UNITED STATES PATENT AND TRADEMARK OFFICE

APPLICATION NO.	FILING DATE	FIRST NAMED INVENTOR	ATTORNEY DOCKET NO.	CONFIRMATION NO.
10/799,201	03/12/2004	Jeoung-Mo Koo	8021-205 (SS-17942-US)	7424
22150	7590	06/27/2005	EXAMINER	
F. CHAU & ASSOCIATES, LLC 130 WOODBURY ROAD WOODBURY, NY 11797			ORTIZ, EDGARDO	
			ART UNIT	PAPER NUMBER
			2815

Office Action Summary

DETAILED ACTION

FIG. 3

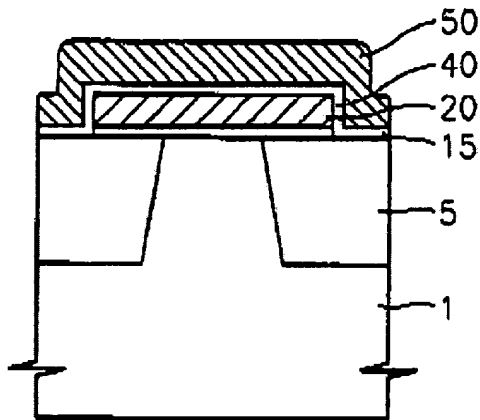
2. Figure 3 should be designated by a legend such as --Prior Art-- because only that which is old is illustrated. See MPEP § 608.02(g). Corrected drawings in compliance with 37 CFR 1.121(d) are required in reply to the Office action to avoid abandonment of the application. The replacement sheet(s) should be labeled "Replacement Sheet" in the page header (as per 37 CFR 1.84(c)) so as not to obstruct any portion of the drawing figures. If the changes are, not accepted by the examiner, the applicant will be notified and informed of any required corrective action in the next Office action. The objection to the drawings will not be held in abeyance.

With regard to Claim 5, Applicant's admitted prior art discloses a control gate (50) that is formed so as to enclose at least one sidewall of the floating gate (20). See figure 3.

FIG. 2K

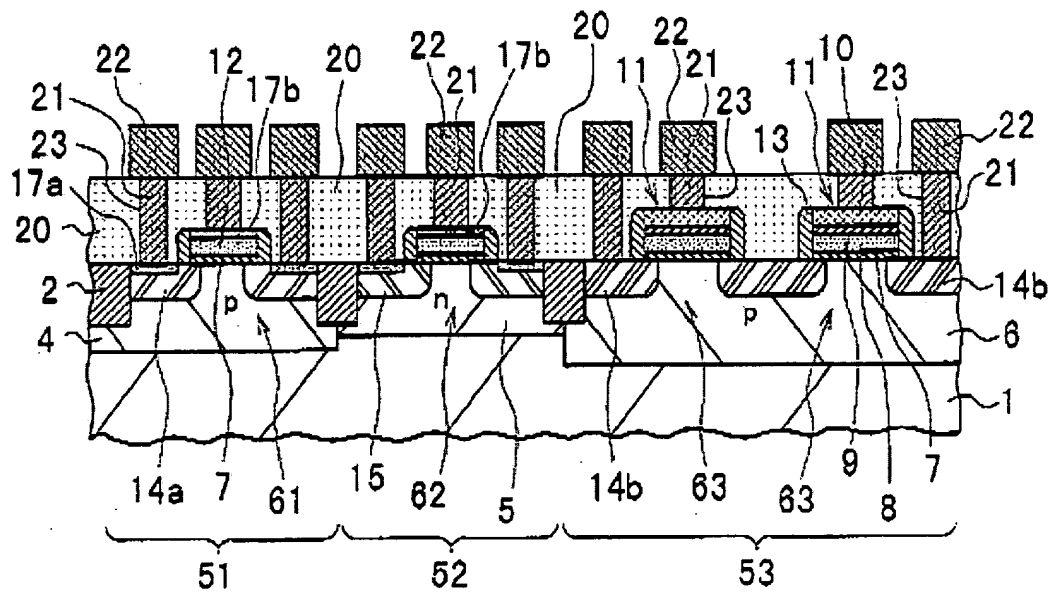
5. Claims 9 and 10 are rejected under 35 U.S.C. 102(b) as being anticipated by Matsubara (U.S. Patent No. 6,037,625). With regard to Claim 9, Matsubara discloses (column 1, lines 7-18 and figure 2K) an integrated circuit, comprising:

a memory device (region 53 column 9, line 2) including an isolation layer (2) which comprises an STI layer and defines an active area including source/drain regions (14b) of a substrate (1), a tunnel oxide layer (7), a floating gate (8) formed over the active area of the memory device and the isolation layer (2), inter-gate dielectric layer (9) formed on the floating gate (8), and a control gate (10) formed on the inter-gate dielectric layer (9);

a first transistor (see region 51) including a first gate (12), a first gate oxide layer (7) interposed between the first gate (12) and the substrate (1), the first source/drain regions (14a)

are formed in the active area at least one of under and adjacent both sides of the first gate (12);
and

a second transistor (see region 52) including a second gate (also labeled 12), a second gate oxide layer (also labeled 7) interposed between the second gate and the substrate (1) and second source/drain regions (15) are formed in the active area at least one of under and adjacent both sides of the first gate (also labeled 12).

With regard to Claim 10, Matsubara discloses a memory device (region 53) including source/drain regions (14b) formed in an active area at least one of under and adjacent both sides of the control gate (10).

With regard to Claim 16, Matsubara discloses on figure 2K an integrated circuit, comprising:

a plurality of isolation layers (2) for defining a first area (53), a second area (51) and a third area (52) in a substrate (1);

a memory device (see region 53) including a floating gate (8) formed over the first area (53) and at least one isolation layer of the plurality of isolation layers (2), an inter-gate dielectric (9) made from layer (39), as shown on figures 2D and 2E, and that includes a composite having a silicon oxide layer and a silicon nitride layer (column 9, lines 20-22) and a control gate (10) formed on the inter-gate dielectric layer (9);

a first transistor (see region 51) including a first gate (12), wherein the first gate (12) is formed in the second area (51) of the substrate on a first gate oxide layer (7) having a thickness equal to a thickness of a tunnel oxide (also labeled 7) formed on the substrate (1) for the memory device (defined by region 53), and a first source region and first drain region (both labeled 14b) formed in the second area (51) at least one under and adjacent both sides of the first gate (12); and

a second transistor (see region 52) including a second gate (also labeled 12), wherein the second gate is formed on a second gate oxide layer (also labeled 7), and a second source region and second drain region (also labeled 14b) formed in the third area (52) at least one of under and adjacent both sides of the second gate (also labeled 7).

FIG. 2

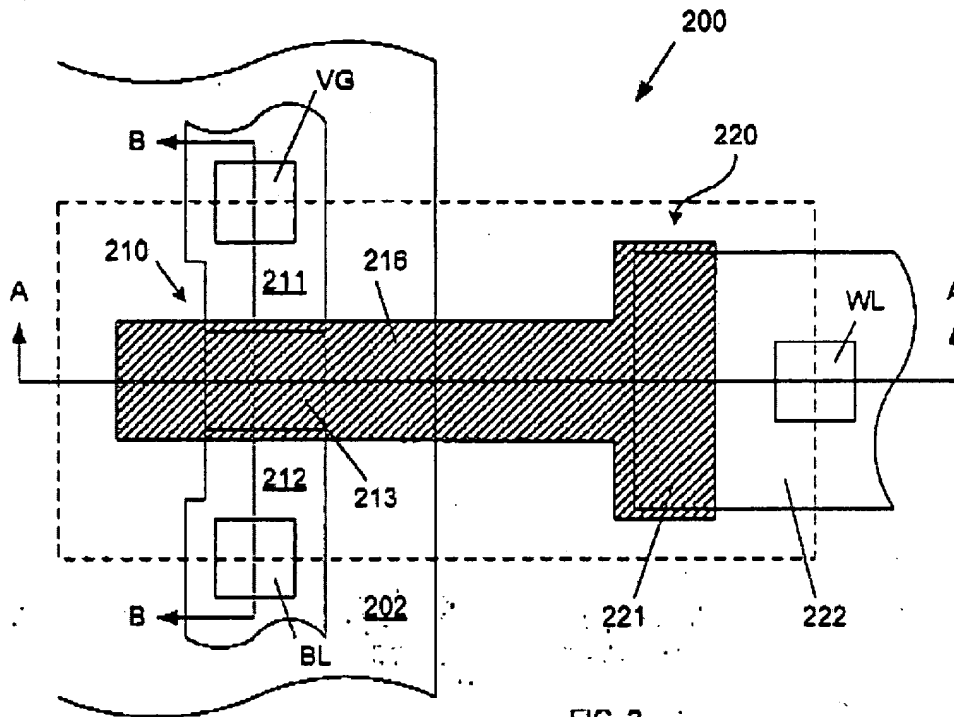
Claim 3 is rejected under 35 U.S.C. 103(a) as being unpatentable over Applicant's admitted prior art as disclosed on figures 1-3 and pages 1-2 of the instant application in view of Hsu (U.S.

Patent Application Publication 2005/0074935). With regard to Claim 3, Applicant's admitted prior art essentially discloses the claimed invention but fails to disclose the claimed portion of the floating gate formed over the active area that is narrower than a portion of the floating gate formed over the isolation layer. However, Hsu discloses (figure 2) a memory cell (200), which includes a floating gate (216) having a portion over an active region defined by source region (211) and drain region (212) that is narrower than the portion of the floating gate that is not over the active region, namely the portion outside region (202).

Therefore, it would have been obvious to someone with ordinary skill in the art, at the time of the invention, to modify the structure as disclosed by Applicant's admitted prior art to include the claimed portion of the floating gate formed over the active area that is narrower than a portion of the floating gate formed over the isolation layer, as suggested by Hsu, in order to facilitate the formation of a contact hole to the floating gate by forming said contact hole in the wider portion.

However, Hsu discloses (figure 2) a memory cell (200), which includes a floating gate (216) having a portion over an active region defined by source region (211) and drain region (212) that is narrower than the portion of the floating gate (216) that is not over the active region.

FIG. 16

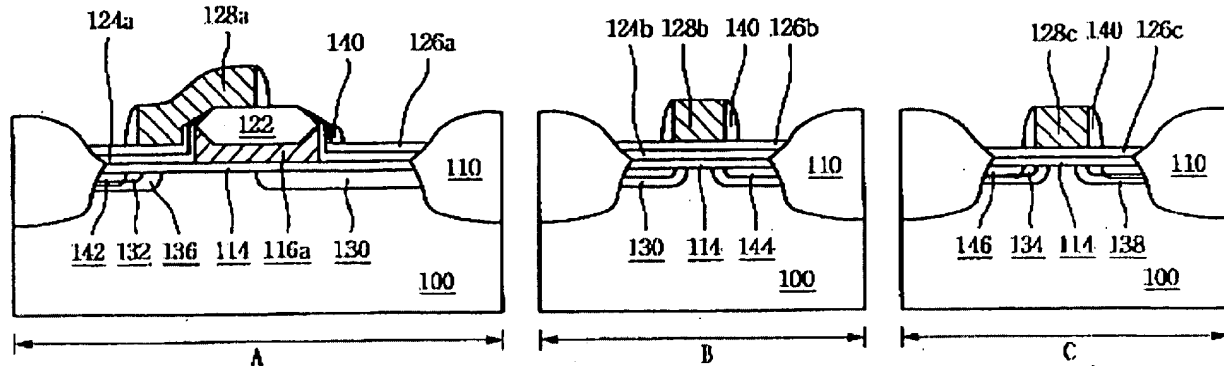
8. Claims 11, 14 -16 are rejected under 35 U.S.C. 103(a) as being unpatentable over Matsubara et al. (U.S. Patent No. 6,037, 625) in view of Lee (U.S. Patent No. 6,348,378). With regard to Claim 11, Matsubara essentially discloses the claimed invention but fails to disclose the claimed second gate oxide layer being thinner than the first gate oxide layer. However, Lee discloses a semiconductor device including a memory device (region A of substrate 100) and transistors (defined by regions B and C of substrate 100), wherein the gate oxide (defined by layers 114 and 126b) of the transistor of region C is thinner than the gate oxide (defined by layers 114, 124b, 126c) of the transistor of region B, as clearly shown on figure 16 and included herein.

Therefore, it would have been obvious to someone with ordinary skill in the art, at the time of the invention, to modify the structure as disclosed by Matsubara to include the claimed second gate oxide layer being thinner than the first gate oxide layer, as suggested by Lee, in order to provide gate oxide layers with different thickness for high and low voltage transistors (column 9, lines 65-67 and column 10, lines 1-4).

Regarding the claimed second gate oxide layer being thinner than the first gate oxide layer, Lee discloses a semiconductor device including a memory device (region A of substrate 100) and transistors (defined by regions B and C of substrate 100), wherein the gate oxide (defined by layers 114 and 126c) of the transistor of region C is thinner than the gate oxide (defined by layers 114, 124b, 126c) of the transistor of region B, as clearly shown on figure 16 and included herein.
